## Pure Gym Ltd

Mather Way, Salford

Reflective Ceiling Plan
Ground and First Floor

F	FOR CONSTRUCTION						
CM/GL		JAN '15	1:200@ /	A3			
<sup>ЈОВ №</sup> 1PG137	DRAW 2-6	ING No	STATUS 	REVISION K

**FIRST FLOOR**

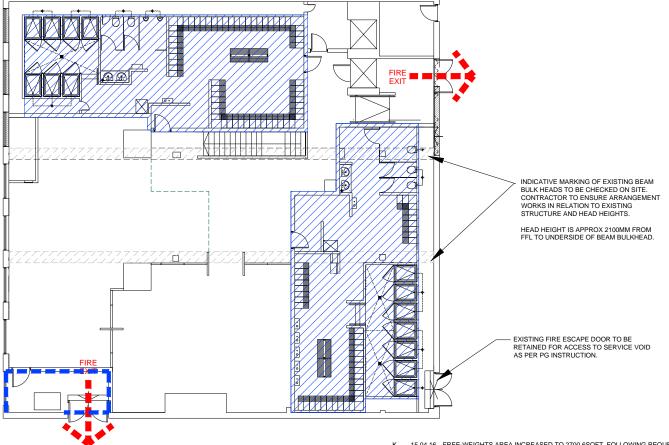
CLIENT				
Α	20.01.16	LAYOUT AMENDED FOLLOWING OPERATIONS REVIEW.	CM	GL
В	28.01.16	RAMP DWARF WALL TO FREE-WEIGHTS REMOVED ADJACENT TO STUDIO AREA, FEMALE CHANGE REARRANGED AND SPIN REDUCED FOLLOWING SITE VISIT 26.01.16. INDICATIVE LOCATION OF EXISTING BEAMS ADDED WITH NOTE. DOUBLE DOORS AND DRAINAGE POINT ADDED TO TANKER ROOM.	СМ	GL
С	02.02.16	STUDIO FIRE EXIT MOVED AND DOORS ADDED FOLLOWING OPS REVIEW	СМ	GL
D	24.02.16	LAYOUT AMENDED FOLLOWING SITE VISIT 11 02.16. FEMALE CHANGE REARRANGED AND SPIN REPOSITIONED. ADDITIONAL SERVICE DOOR ADDED, POSITION AND SIZE OF BULK HEADS ADJUSTED FOLLOWING STRIP OUT OF DEMISE. BALUSTRADE AND DWARF WALL LOCATED AT TOP OF STAIR ON FIRST FLOOR. DOOR TO EXISTING ELECTRICAL ROOM MOVED TO ALLOW FOR DROP DOWN LADDER FROM ACCESS HATCH TO ROOF PLANT. PRIVACY SCREEN ADDED TO STUDIO FOLLOWING NOTE FROM PG. DRAWING AMENDED IN LINE WITH 2-200H.	СМ	GL
E	04.03.16	SERVICE DUCT EXTENDED FROM 300MM TO 700MM TO SIDE OF MALE CHANGE SHOWER FOLLOWING SLR REVIEW. ADDITION OF DOOR TO NEW SUPPLY AND EXTRACT TERMINUS ADJACENT TO THE REDUNDANT LIFT ON THE FIRST FLOOR. WALL ADDED TO FREE-WEIGHTS AREA TO REFLECT SITE.	СМ	GL

F	17.03.16	PRIVACY SCREEN TO STUDIO REPOSITIONED TO ALLOW MORE STUDIO FLOOR AREA FOLLOWING COMMENTS FROM PGL.BRANDING PROPOSALS UPDATED. MHA TITLE BLOCK UPDATED.	СМ	GL
G	29.03.16	DRAWING UPDATED IN LINE WITH REV M	CM	GL
Н	30.03.16	DRAWING UPDATED IN LINE WITH REV N	CM	GL
1	11.04.16	UPDATED IN LINE WITH GA PLAN REVISION P	SB	CN
J	12.04.16	UPDATED IN LINE WITH GA PLAN REVISION Q	CM	GL
К	15.04.16	FREE-WEIGHTS AREA INCREASED TO 2700.6SQFT FOLLOWING REQUEST FROM PG.	СМ	GL
